DESIGN MEMORANDUM No. 03-18
TECHNICAL ADVISORY

SUBJECT: Guardrail at Culverts

SUPERSEDES: *Indiana Design Manual* Sections Described Below

Figure 55-5A₁

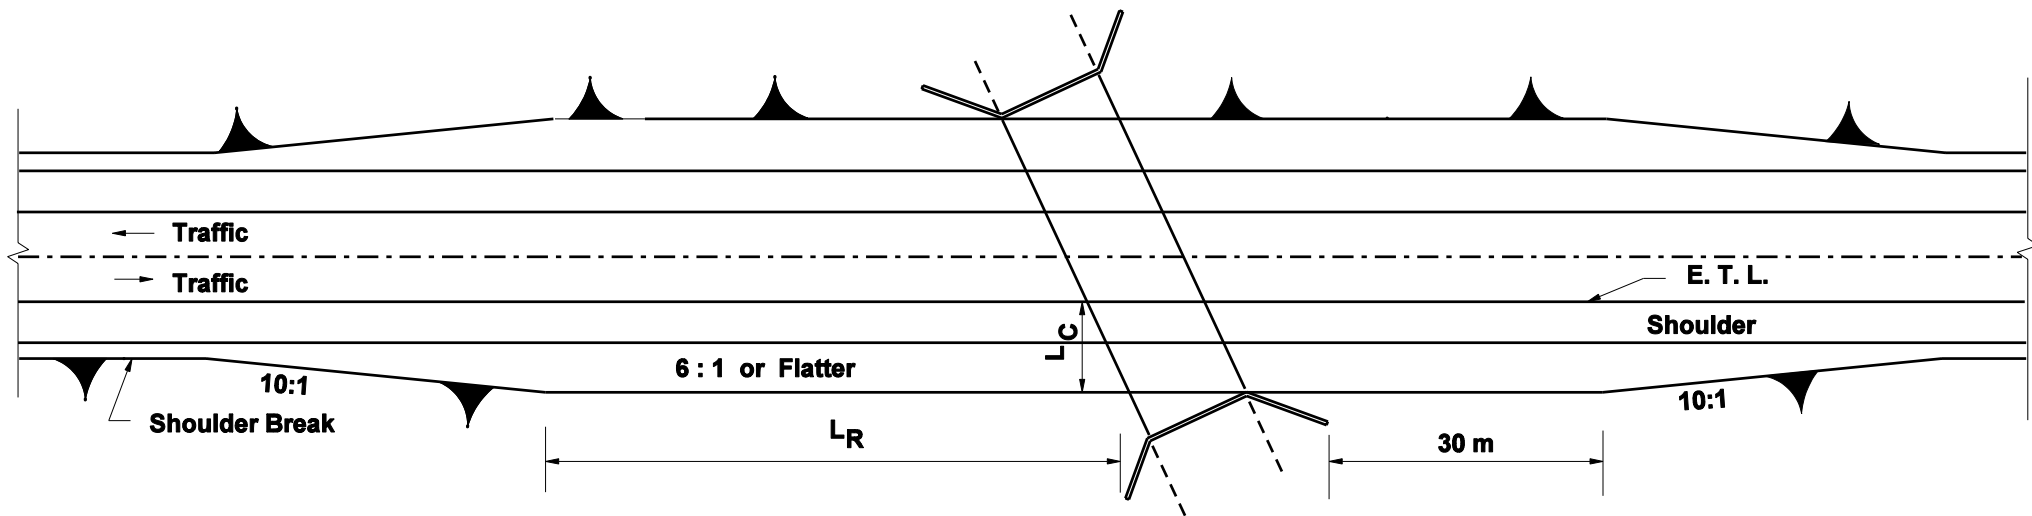
4. If the point at which the top of the box culvert or 3-sided structure protrudes from the slope is within the obstruction free zone, guardrail should typically be provided. Otherwise, Figure 55-5A₁, Clear Zone / Guardrail at Culverts, should be used to determine the appropriate treatment.

Span	Rise	Treatment
≤ 10 ft	All	B preferred; A acceptable
> 10 ft	< 66 in.	B preferred; A acceptable
> 10 ft	≥ 66 in.	B

- A Provide a clear zone with 6:1 slopes or flatter at least a distance L_R in advance and 30 m beyond the structure. Taper 10:1 on both sides of the structure to tie back in.*
- B Guardrail should be placed. Use treatment A if guardrail is impractical due to the close proximity of public road approaches or drives. Driveway grades should be designed to be compatible with clear-zone slopes. Driveway sideslopes should be 10:1.*

LARGE DRAINAGE STRUCTURES WITH CLEAR ZONE
Figure 55-5B

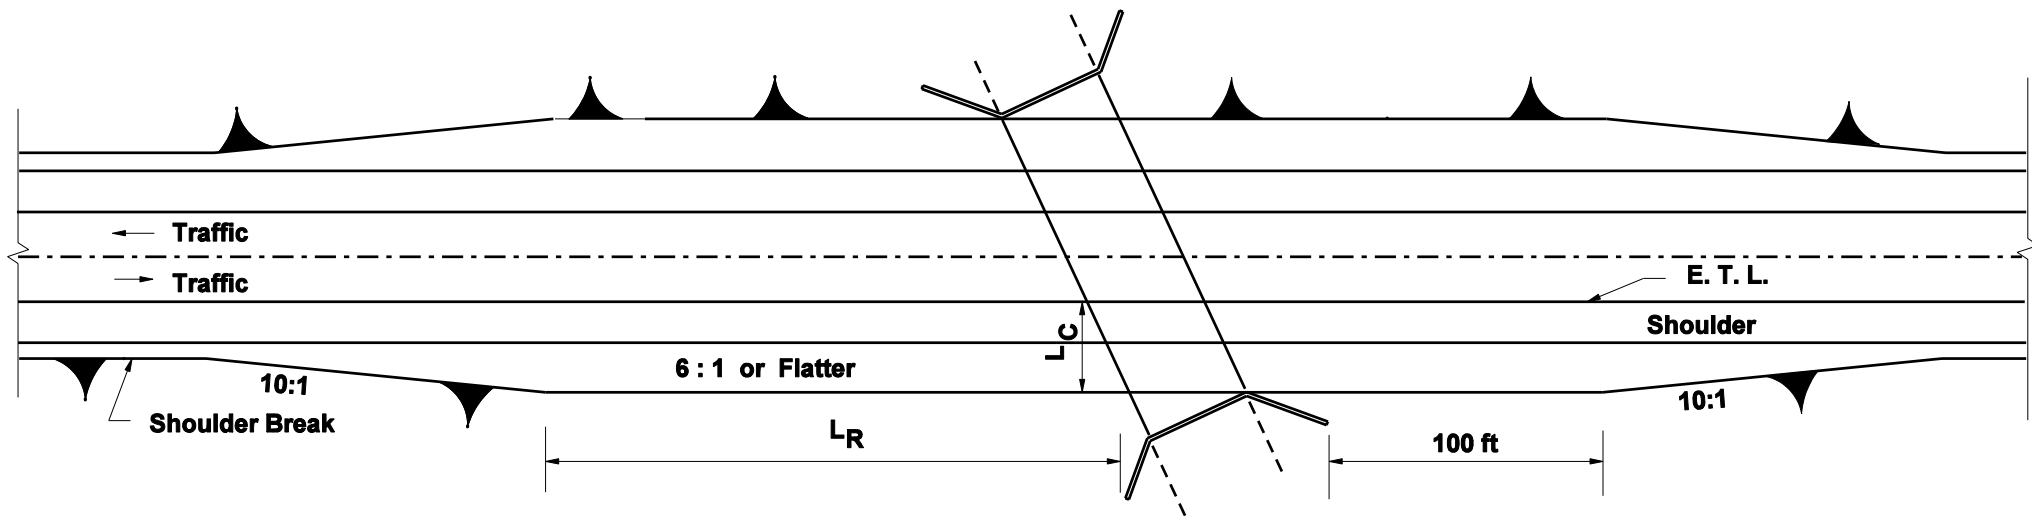
- A Provide a clear zone with 6:1 slopes or flatter at least a distance L_R in advance and 30 m beyond the structure. Taper 10:1 on both sides of the structure to tie back in.*
- B Guardrail should be placed. Use treatment A if guardrail is impractical due to the close proximity of public road approaches or drives. Driveway grades should be designed to be compatible with clear-zone slopes. Driveway sideslopes should be 10:1.*
